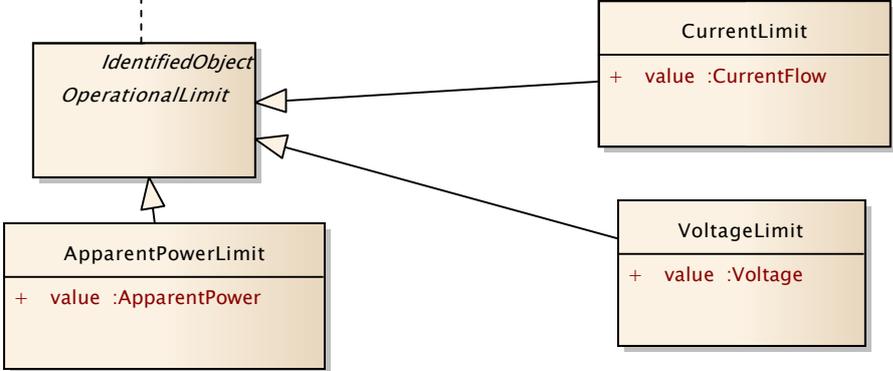
TapChanger.regulationStatus is now optional in EQ profile. I would suggest to delete this in EQ and put it in OH profile as required.  
 On the TapChanger we are missing position attribute which is now in the SV class. How we could deal with this?  
 We could have some attribute initialPosition which is the one to be used in the OH profile  
**IOP call reply:**  
 - TapChanger.regulationStatus - default value - in the EQ; if this goes to OH it could be used in case there is multiple devices using one RegulatingControl.  
 - We need actualPosition - for OH. To-Do for WG 13  
 - the solved one is in the SV

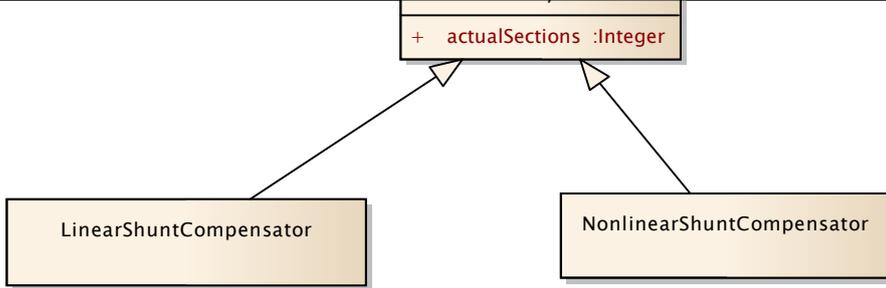
The 3 classes for limits are now in EQ => they would go to OH i.e deleted from EQ profile

**IOP call:**  
 For now we keep limits in the EQ;
